Service Advisory

CC-519

Subject: **759-04119 Fender Replacement Service Kit**

Subject: Rear Fender Replacement

FIGURE 2

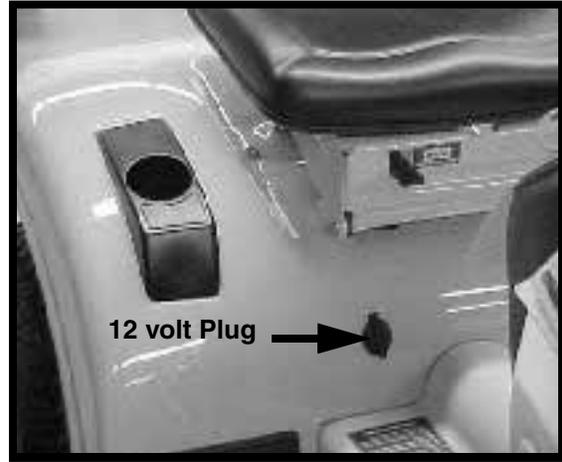
Service Kit 759-04119 will replace the fender style (703-2278B) shown in **FIGURE 2**. Service Kit 759-04119 will also replace the fender style (703-05570) shown in **FIGURE 3**, except the hole for the 12 volt accessory plug will need to be drilled and all parts transferred from the old fender assembly.

Service Kit 759-04119 will consist of a fender, LH & RH fender covers, 8 hex tap screws, and an instruction sheet. The photo in **FIGURE 4** shows what the fender assembly will look like when the 759-04119 kit is installed. **NOTE:** The lift height indicator must be removed when the 759-04119 kit is installed.

FIGURE 1

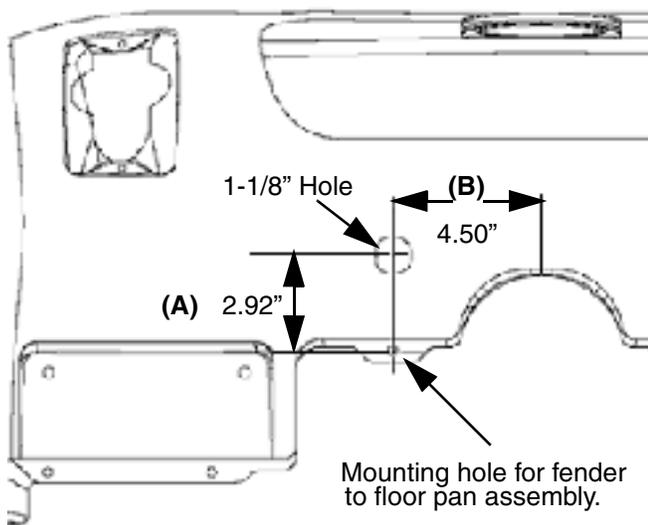
16. If the Tractor is a 2005 Model with the 12 volt power receptacle located in the fender above the floor pan on the right hand side off center. A hole is not provided for this and will need to be drilled at this time. The Location for the 12 volt power receptacle hole is shown in **FIGURE 1**. You will need to drill a 1-1/8" hole, 2.92" above the center of the mounting hole used for mounting the fender to the floor pan (**A**), and 4.50" from center line of fender to the center of 1-1/8" hole (**B**).

17. If this action is not desired. Your options are as follows.
 - A.** Relocate the 12 volt power receptacle to another location, (Keep in mind that a mounting hole will still be required).

- B.** Do not install the 12 volt power receptacle and tape up the two wire leads with electrical tape. If this is done remember that the one lead for the receptacle is a 12 volt power lead and is hot at all times. Be sure to properly secure wire leads out of the way to prevent any shorting of the electrical system.
